SUBJECT: **Petition PB-17-33 MSC** Kurt & Renee Strauss, owners. Amend the Northeast Residential Historic District map to change the status of the house from a non-contributing structure to a contributing structure and show the new accessory structure as non-contributing. Located at 1216 NE 4th Street.

TO: Historic Preservation Board **Item Number: 2**
FROM: Department of Doing, Planning Staff **DATE:** March 07, 2017

SUBJECT: **Petition HP-17-06a.** Kurt & Renee Strauss, owners. Certificate of Appropriateness for exterior rehabilitation of single-family house. Work includes replacement of vinyl siding with stucco, replacement of doors and windows, replacement of structurally deficient chimney and rear bedroom addition, installation of exterior fencing, replacement of existing accessory structure, and a zoning modification request for accessory structure setbacks. Located at 1216 NE 4th Street. This building is non-contributing to the Northeast Residential Historic District.

SUBJECT: **Petition HP-17-06b.** Kurt & Renee Strauss, owners. Review of proposed rehabilitation work for determination of meeting criteria for a contributing structure, and review of status change of the pr

13 & 14: Existing accessory structure at southwest corner of property.

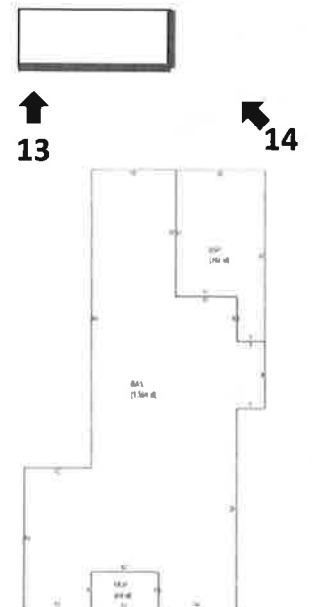
The Owners also propose to remove a non-contributing accessory structure (c. 1950s) and replace with a new garage structure which will incorporate a workshop, guest room and bath. This new structure requires a zoning modification request for side and rear setbacks.

15: Original chimney and fireplace are structurally deteriorated and do not meet code requirements. Chimney is leaning and hearth tile is cracked and sinking.

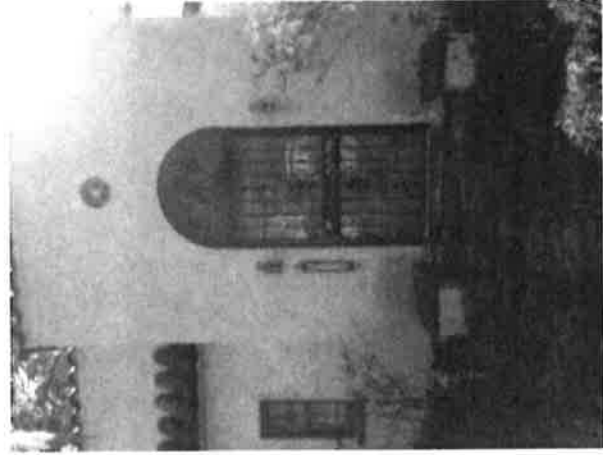
The existing chimney is a masonry structure with stucco exterior. It is original to the house, but leaning and sinking, as is visible in the exterior photos and in the cracking of the hearth tile. The Owner has had masons examine the chimney for repair or rebuilding but the deterioration would require complete rebuilding without assurance that the chimney and hearth wouldn’t sink again. The Owner proposes to remove the existing chimney and rebuild the hearth,

chimney box and chimney to match the appearance of the original. The new chimney would be constructed of wood framing, with exterior stucco. The dimensions of the firebox would need to be slightly deeper in plan in order to meet code.

A2

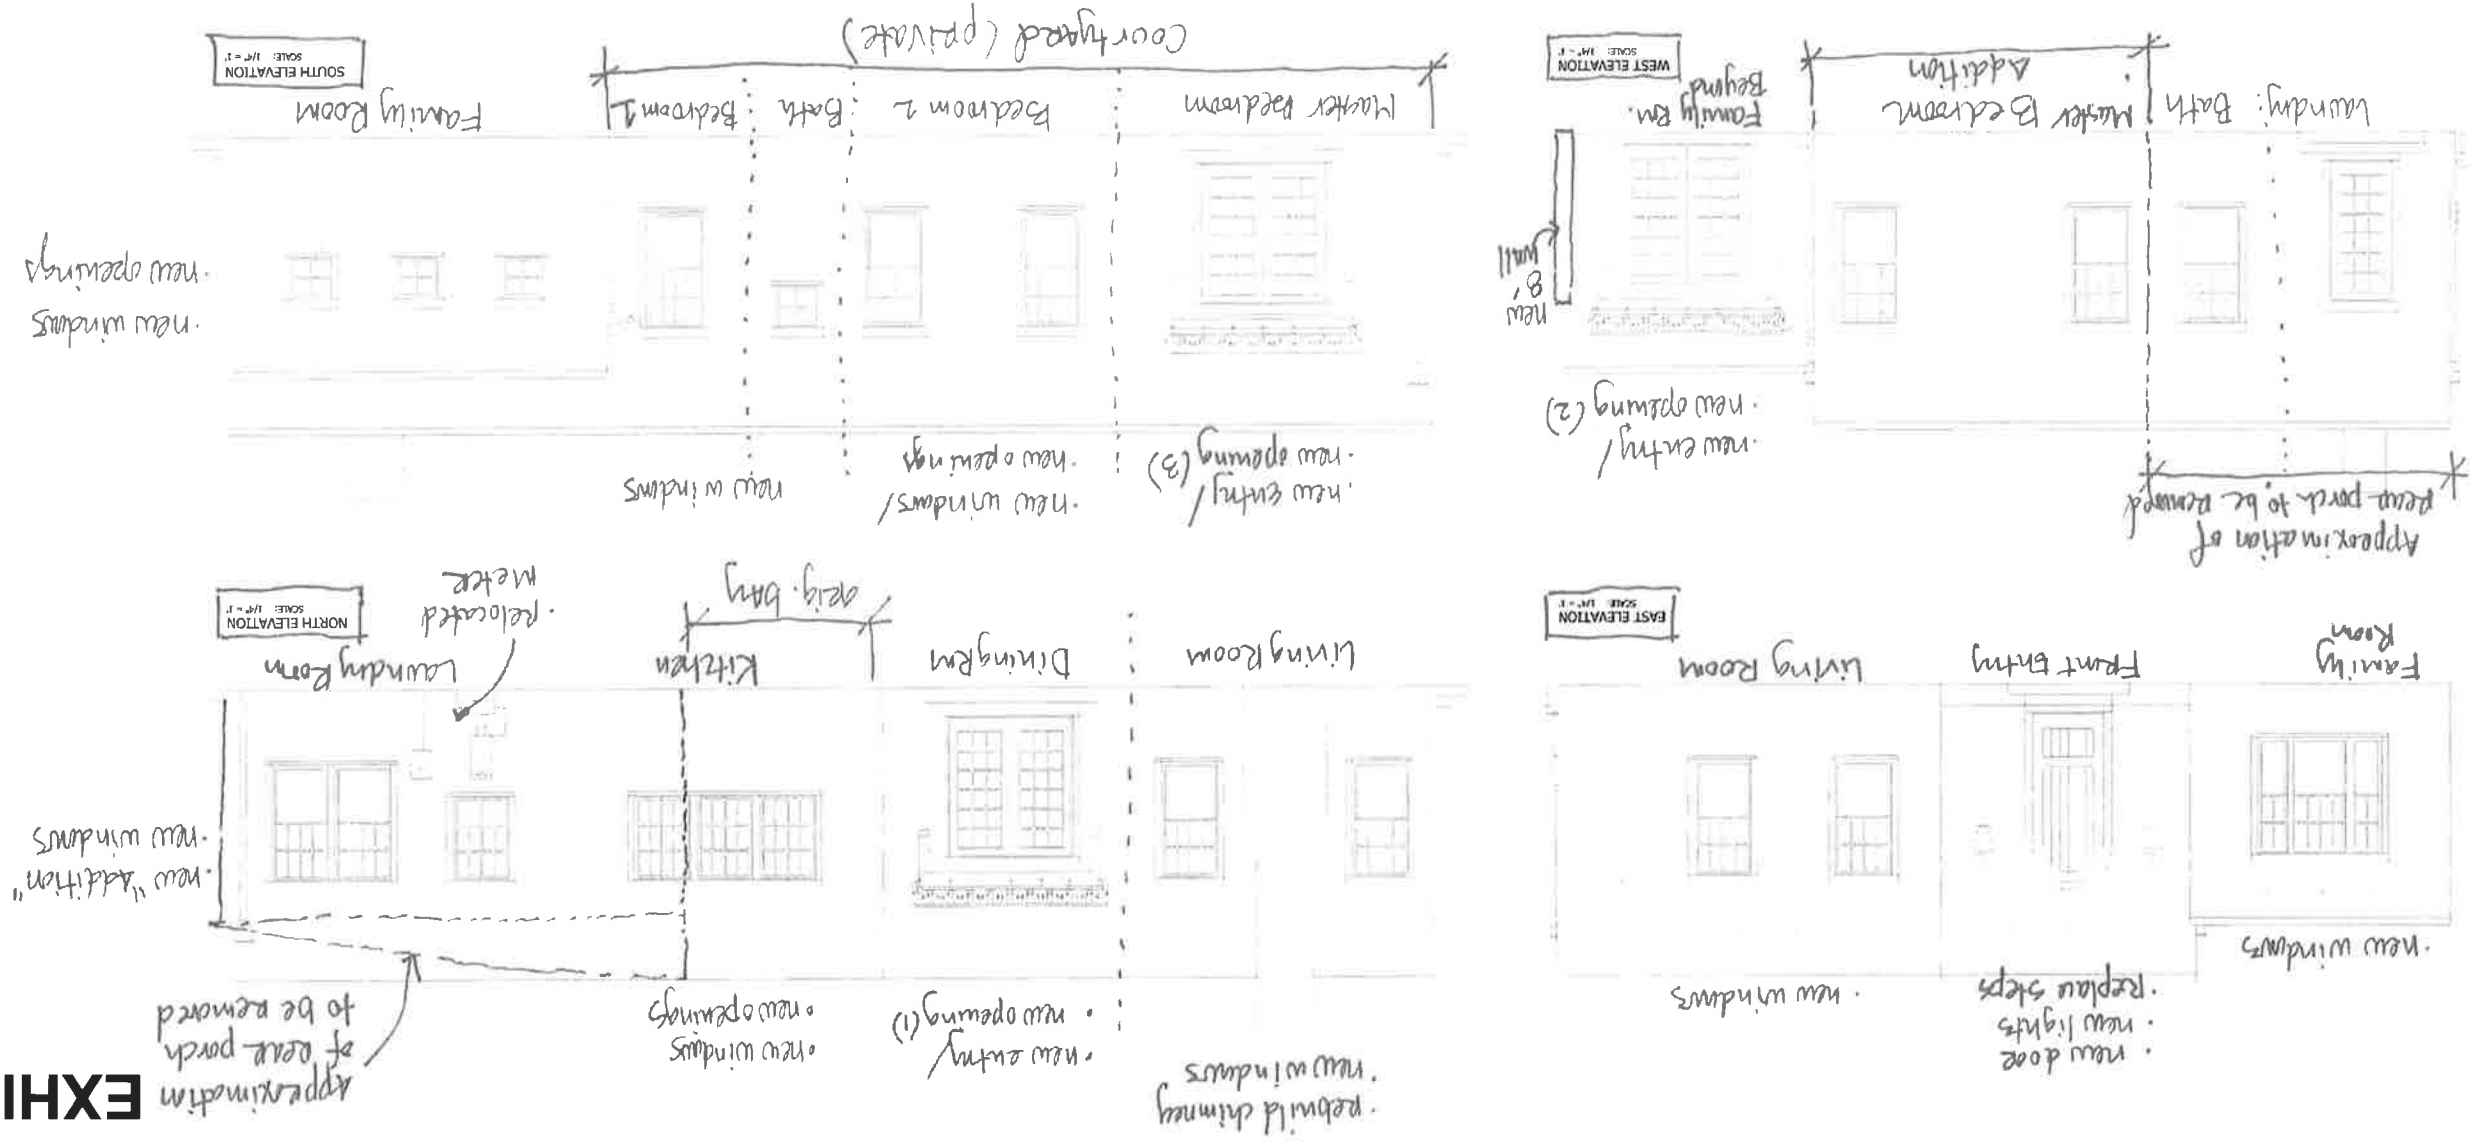
French Doors and New Openings (Refer to Exhibits 3 & 4, noted drawing A2)

There are three new openings proposed with double French Doors and an entry awning with clay tile roofing. The entry awning design and Entry 1 (on the North Elevation of the original house) are both covered under Board Review. Entry 2 (west elevation of original carport enclosure), Entry 3 (south elevation of Master Bedroom addition), and a new single French door entry (on the west elevation at the Laundry Room) are all on "less-visible secondary

Staff understands that the floor plan of the kitchen, laundry room and bathroom are compact and there is not a lot of room for removal of square footage in these areas. However, Staff recommends a small redesign of the addition to differentiate it from the original kitchen bay and master bedroom addition. The addition could be recessed back from both walls by a few inches, creating a reveal that would acknowledge the original bay and master bedroom

- small redesign of the addition to differentiate it from the original kitchen bay and master bedroom addition, by recessing the new addition, by using new sympathetic materials, lowering the roofline/ parapet, and similar strategies.
- Board decisions on reconfigurations of:
 - north elevation new door opening and new entry canopy
 - new window openings: family room (south elevation), kitchen and laundry room (north elevation)

NORTH ELEVATION
SCALE: 1/4" = 1'

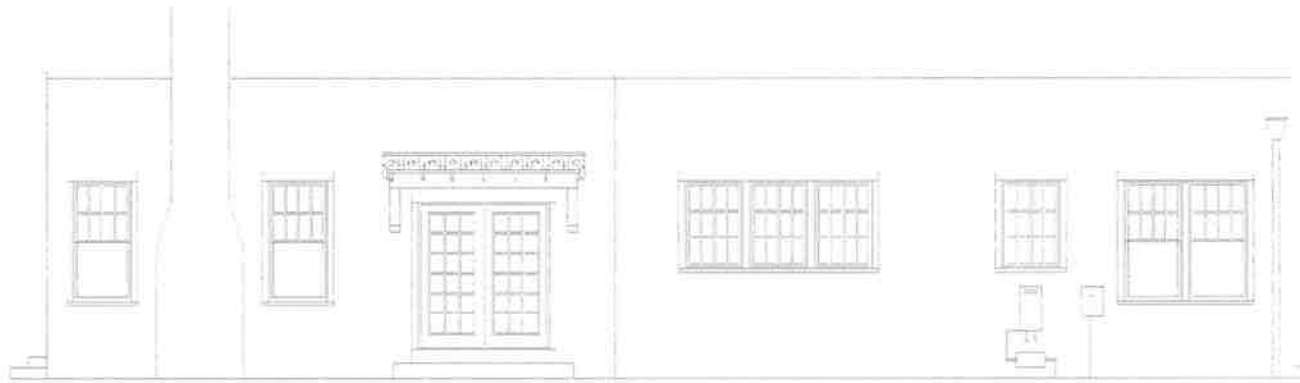
Staff also recommends the board discuss the casement window configuration for the kitchen and laundry room on the north elevation. Staff recommends the board consider the window installations in conjunction with the proposed new door opening in the Dining Room and the construction of the addition to replace the rear screen porch.

SITE PLAN
SCALE: 1/8" = 1'

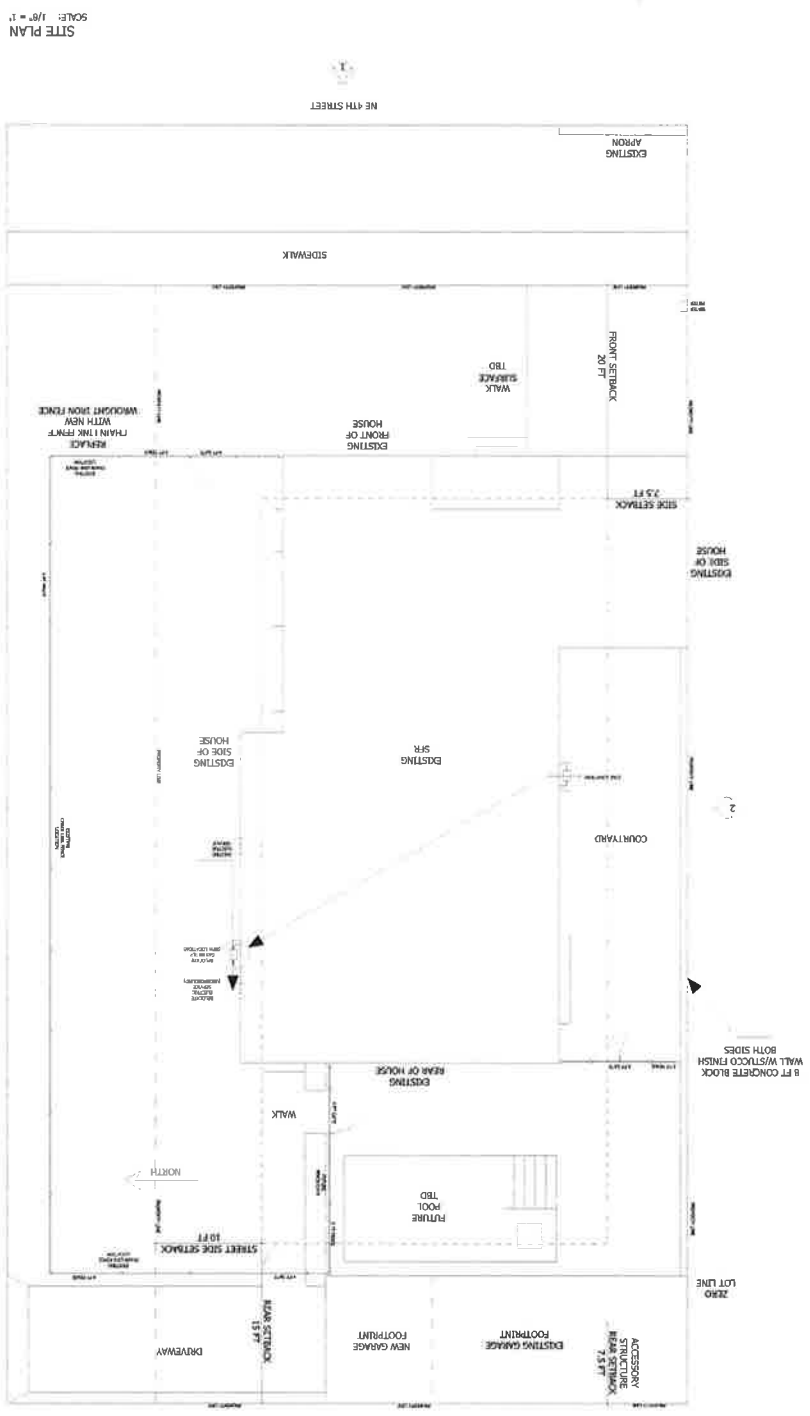
The existing property is enclosed by a chain link fence. The proposed fence is a 36” tall wrought iron fence with slender pickets and pointed finials. The fence will approximate the existing location of the chain link fence surrounding the yard on NE 13th Avenue. New fencing will also be installed between the house and the new accessory structure and at the rear courtyard. Refer to Sheet A3 for plan locations.

The proposed privacy wall is an 8'-0" tall concrete block structure, capped with a bond beam and stuccoed on both sides to match the house. The wall will be located at the property line on the south side of the property and will run flush from the edge of the house to the new accessory structure. Refer to Sheet A3 for plan locations.

Staff finds the placement of the wall behind the house, flush with the house wall, and not on a primary façade as an appropriate location for a privacy wall to create a courtyard (private backyard) for a house located on the corner. Staff finds solid masonry and the stucco material of the wall appropriate for the architectural character of the house and that they relate to other houses of similar design in the historic district (Refer to Exhibit 2, p. 16). Staff recommends the wall height be lowered to 6'-0", which is a height that will provide privacy considering the solid character of the wall.

The Owner is requesting zoning modification for the side and rear setbacks of the new accessory structure. The existing structure that will be demolished is basically on the lot line and the Owners would like to retain that setback spacing to allow the existing yard to remain, approximately 16' between the structure and the rear wall of the house, as well as to allow room in the driveway for a vehicle, as the new building will be used as a workshop and guest room. Refer to Sheet A3 for site plan.

- the new privacy wall height be lowered to 6'-0" per the guidelines
- submission of gate design and samples of color selection for exterior canopy tile for Staff review once designed
- landscape screening of relocated utility equipment on the north façade
- submission of front door cutsheet when selected, showing a door in proportion with the original arched opening height
- submission of any revisions to documents for permitting for Staff review, including the materials and design for the walking surface noted as TBD on the existing drawings
- Approve the *Application for Modification Existing Zoning Requirements* requesting a modification of the side and rear setback from 7.5' to 0'.

A4

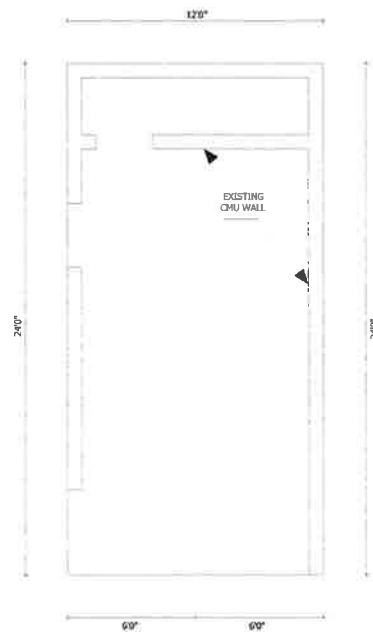
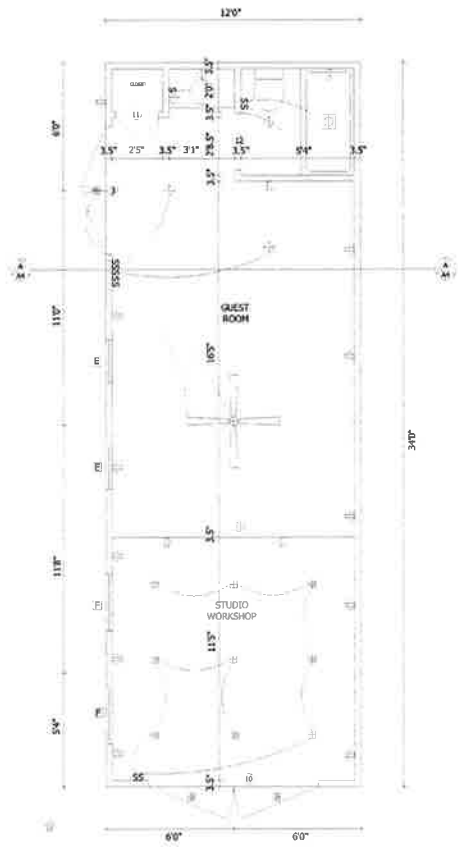
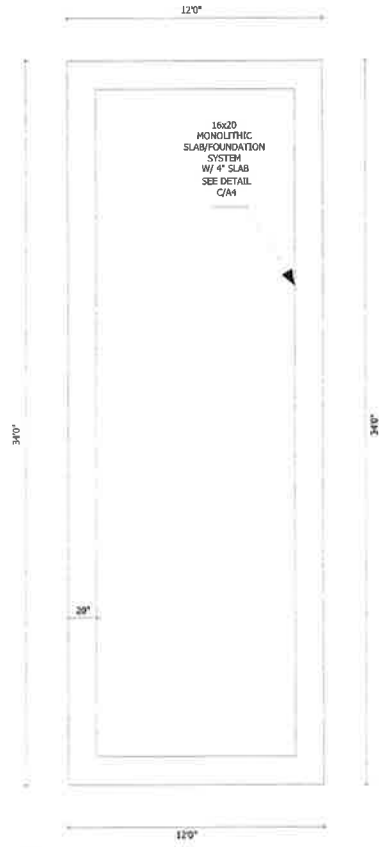
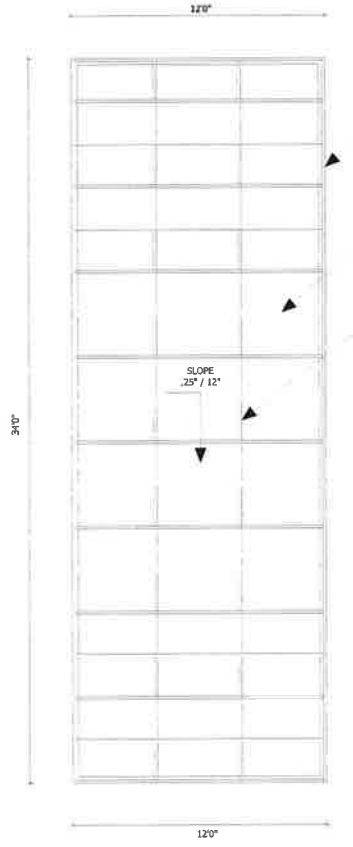
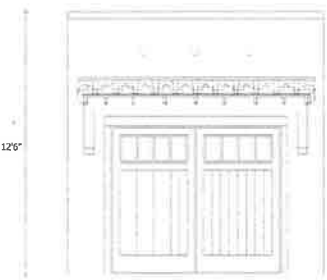
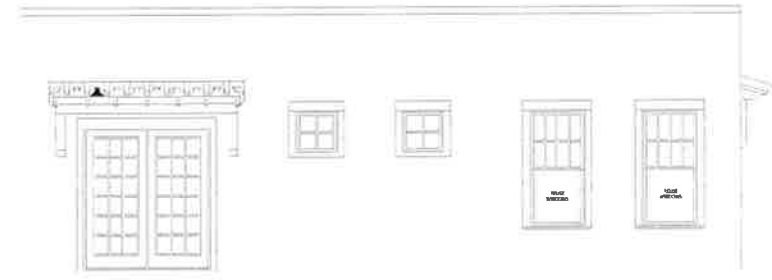
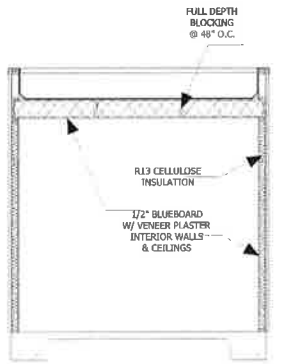
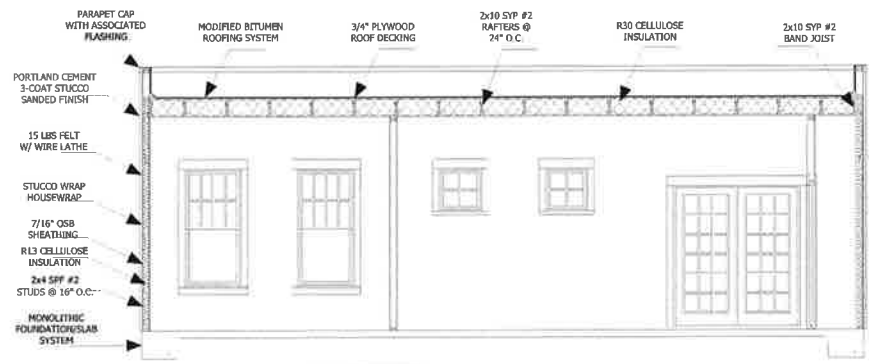
With the new double French door openings, a new entry canopy is being proposed. Refer to detail on Sheet A4. The brackets for the canopy are wood and the roofing is a clay tile. The style of this entry canopy is similar to many homes of similar architectural character in the historic district (Refer to Exhibit 2, p. 16).

Staff finds the design of the new structure appropriate for its overall architectural character in that it takes its design cues from the main house. The building is located at the rear of the lot and the size does not detract from the house, especially by its proposed location in the footprint of the original, abutting the property lines (requiring a setback modification).

Per RSF-3 zoning, the rear and side yard setbacks for an accessory structure are 7.5'. The Owner is requesting 0' setback on both sides. The proposed elevations for the accessory structure will be stucco walls at 12'-6" height. Refer to Sheet A4 for drawings.
